National Beyond visual line of sight Experimentation Corridor  
Airspace Change Proposal

**Targeted Engagement report**

14 May 2021

# Engagement report – Cranfield NBEC ACP

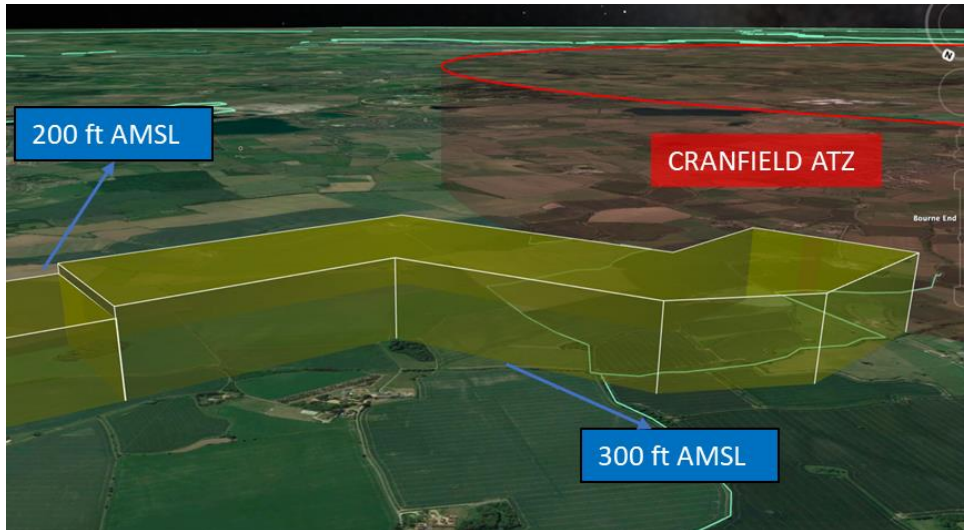
A further review of the route considering avoidance of villages was also conducted.

- The airspace will be activated by NOTAM.
- NOTAMs will include contact details including Cranfield ATCs telephone number and frequency.
- NOTAMs will be published at least 24 hours in advance.
- Cranfield ATC will provide both a Danger Area Crossing Service (DACS) and a Danger Area Activity Information Service (DAIS) as described in Appendix E.
- UAV flight path routing has been adjusted to minimise residential overflight.
